REMARKS

Summary of the Office Action

Summary Of Applicant's Response

FIG. 1

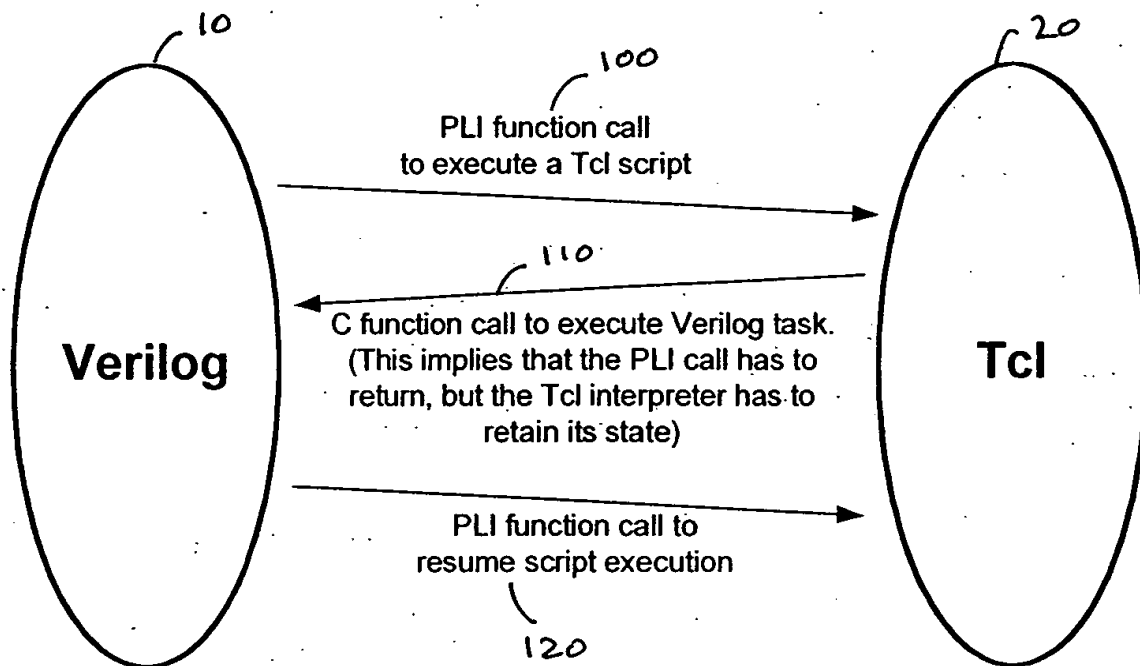
The drawing has been objected to under 37 C.F.R. § 1.84(p)(5) because reference signs mentioned in the description are not included in the drawing.

The drawing has been objected to under 37 C.F.R. § 1.84(p)(5) because reference signs mentioned in the description are not included in the drawing. Applicants have proposed adding the label "FIG. 1" and reference numerals "10," "20," "100," "110," and "120" to FIG. 1. The corrections to the drawings will be incorporated in the formal drawings if approved by the Examiner.

APPROVED
